marantz® SERVICE BULLETIN		Date: 10-Dec-2004	Model: DV9500
		Page: 1 / 4	REF.NBR: MZ04-081
Level		Application:	
★ ★ ★		See below	
		Subject: No power or does not operate after display with "MARANTZ"	
		Int.ref:

When Power ON/OFF is repeated, intermittently no power or does not operate after the "MARANTZ" displayed on FLD.

1-(1) Remove RU02, RU03, RU04

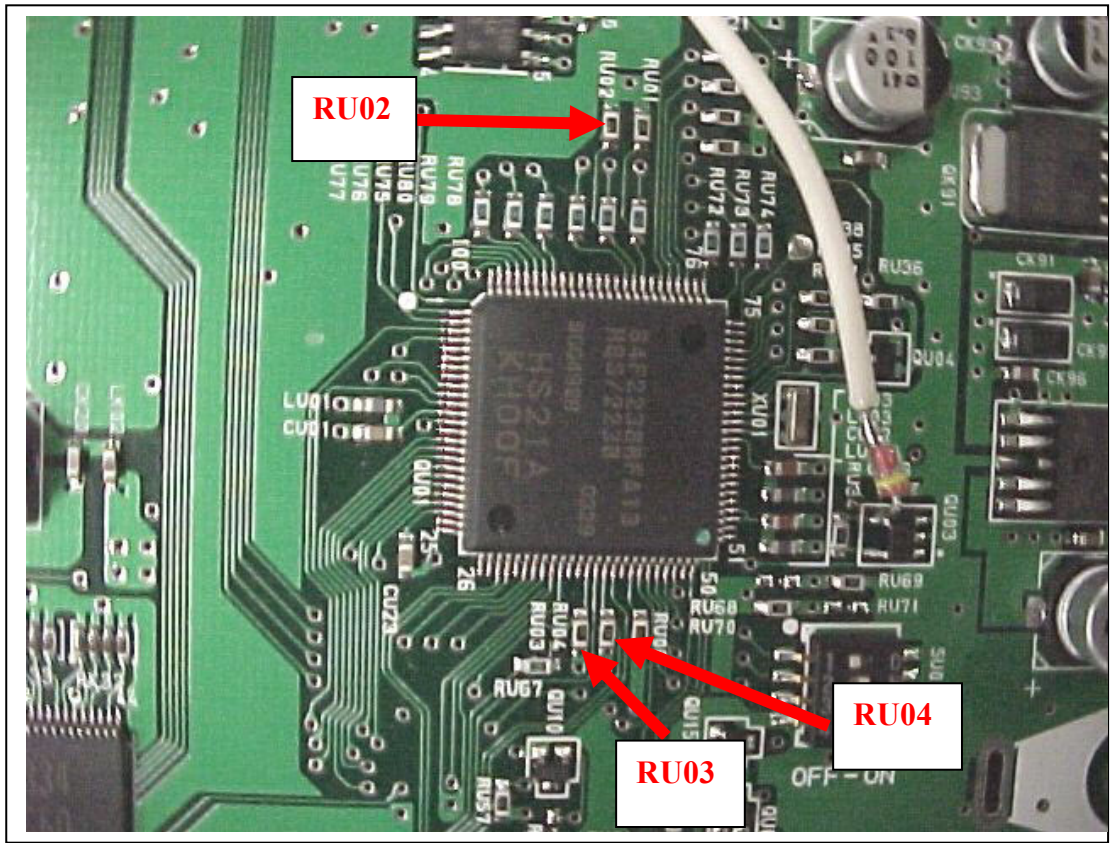
- 1-(1) POS.NO **RU02, RU03** and **RU04** (Chip Resistor 10K OHM +-5% 1/16W) are **removed**.
- 1-(2) **A wire is added**.
- 1-(3) **Schottoky-diode** (part no.: **00MHD20008020**) is **added**.
- 2. **Update Back End Software (firmware) version to [B.0.34B]. Update Disc part no.: 90M-DV9500BE2.**
- 3. **Update PANEL Software (firmware) version to [P0.91]. Update Disc part no.: 90M-DV9500CDR**

1-(2) Add a wire.

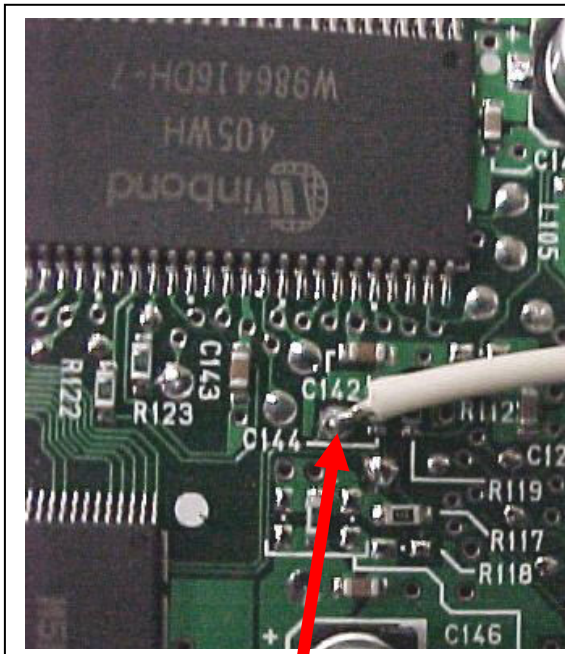
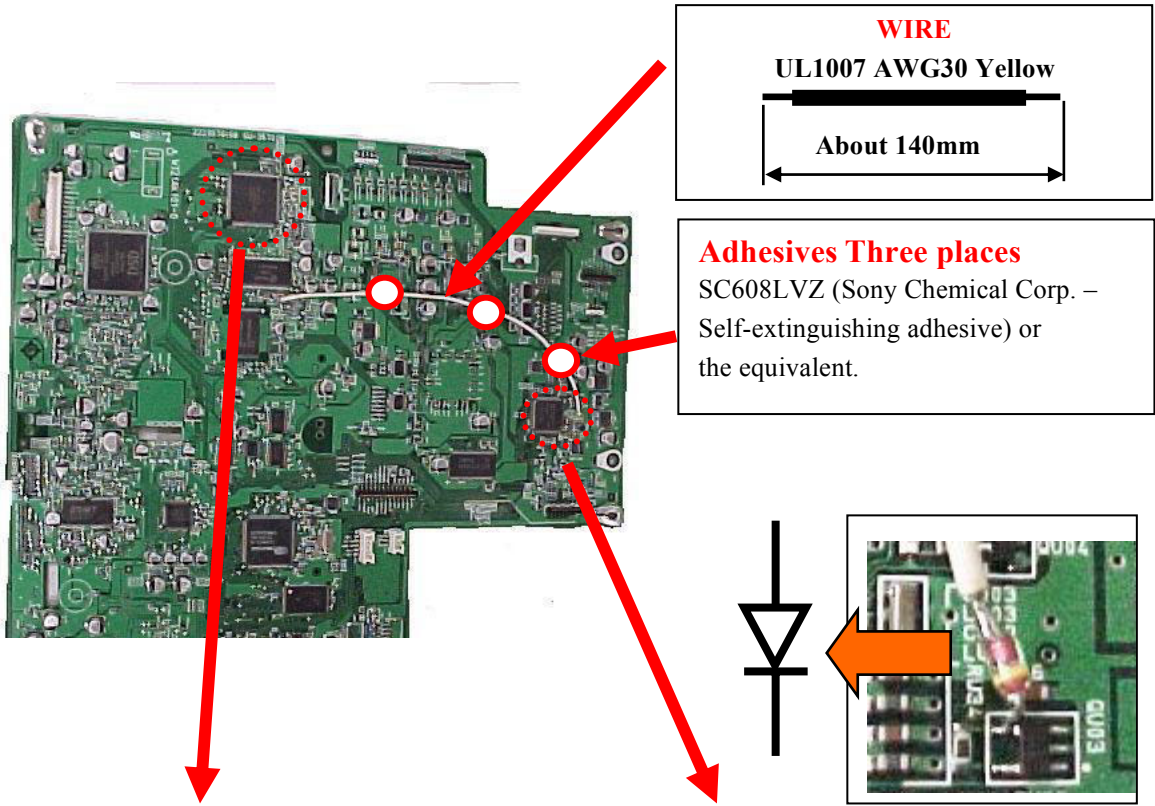
Connect a wire to this Test point (No.12 pin of Q103)

1-(3) Add a Schottky-DIODE (part no.: 00MHD20008020)

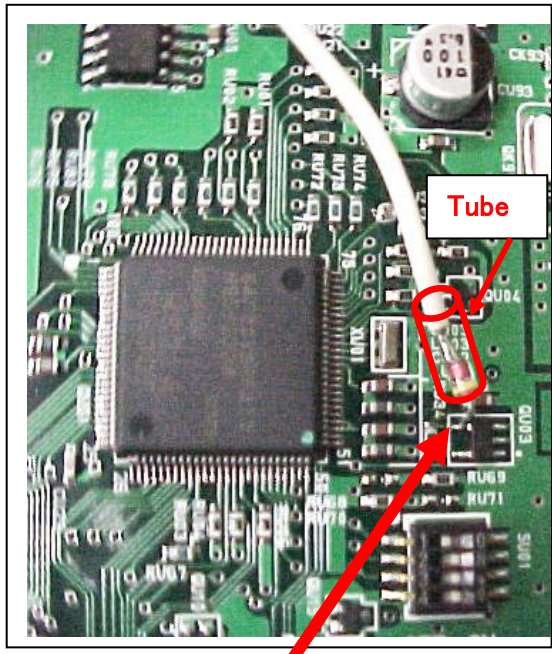
1. Add Schottky-DIODE and Insulation Tube.
2. Connect a wire to No.4 pin of QU03
